8.1 Appendix 1 - Consultation comments record

# Pre-application 1 proposal - 12th September 2017

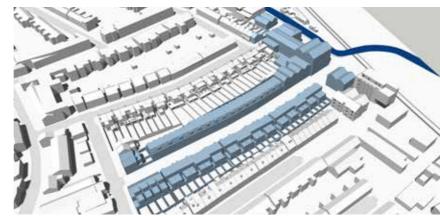
### Scale and Massing

- The proposal for a six storey building at the northern end of the site was considered excessive and over-development
- The scheme should avoid impacting on views from: across Crane Valley; on the small scale surroundings; and on the Hamilton Road Conservation Area

### Scale and Massing

- Massing of taller building was reduced from six to five storeys
- Top floor of townhouses redesigned as a pitched/mansard roof to reflect neighbouring loft conversions and to reduce visual impact from the new street

Public exhibition scheme markup with areas to be amended

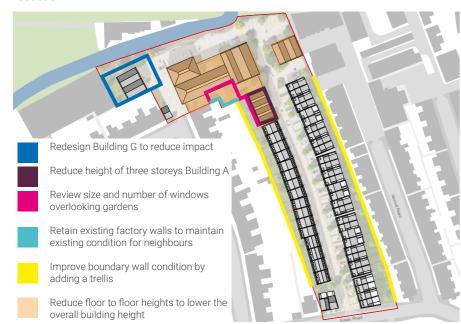
### Gould Road residents' privacy and aspect

- Residents who live towards the eastern end of Gould Road were concerned about potentially being overlooked by new residents
- There was also concern over the proximity of the proposed apartment building backing onto their gardens and loss of views, light and overshadowing

# Crane Road residents' privacy and aspect

- Some residents who live towards the northern end of Crane Road were concerned about potentially being overlooked by new residents
- There was also concern over the height of the proposed apartment buildings and the impact that would have on their views and aspect

### Gould Road residents' privacy and aspect

This small apartment building was designed to change the configuration to directly address these concerns.

- The building footprint was moved off the site boundary edge with back-to-back gardens similar to the condition elsewhere in the area
- The massing of the proposals was considerably reduced so that it is now just one storey adjacent to the boundary with accommodation in the first floor roof, losing an entire floor from the previous proposal
- A low pitch ensures no overlooking towards adjoining houses and only views northwards from first floor or towards the sky through the rooflights

### Crane Road residents' privacy and aspect

- The saw-tooth roof along the western edge (backing onto Crane road gardens) was removed and the eastern edge reduced
- The size and number of windows overlooking Crane Road gardens from apartment buildings were reduced in size or removed altogether where possible
- The accessible area of roof terraces were set-back from the roof edge to avoid overlooking
- Floor to floor heights were reduced to minimise the overall building height
- Existing boundary factory walls where on the red-line boundary have been retained where structurally possible to maintain existing condition for neighbours
- Look at improving privacy further by introducing a trellis to boundary walls

Section showing visibility splay from balconies

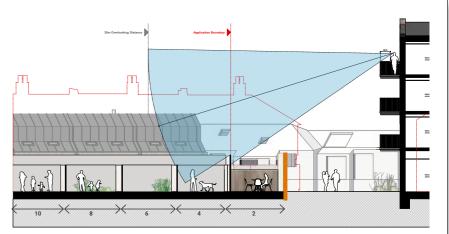
### Overlooking & privacy

Fourth storey and balconies to the western end of Building F could have a negative impact and potential overlooking.

### Overlooking & privacy

A full review of overlooking has been undertaken on these properties. The current proposal does not overlook existing windows, but does partially overlook the gardens of 4 Gould Road. Overlooking of gardens is a common condition within the area and within London and was considered acceptable by officers as part of the previous application. It is also important new apartments are provided with balconies where possible to meet London Plan.

However the design incorporates the following changes to reduce this perceived overlooking to benefit the existing owners of the gardens.

- Overlooking to neighbouring gardens minimised by garden of number 2 Gould Road and proposal to increase height of existing perimeter wall at site application boundary;
- Balcony railings amended to blades directing views towards the river providing residents with additional privacy and reducing overlooking from those sitting on the balcony or within the rooms.
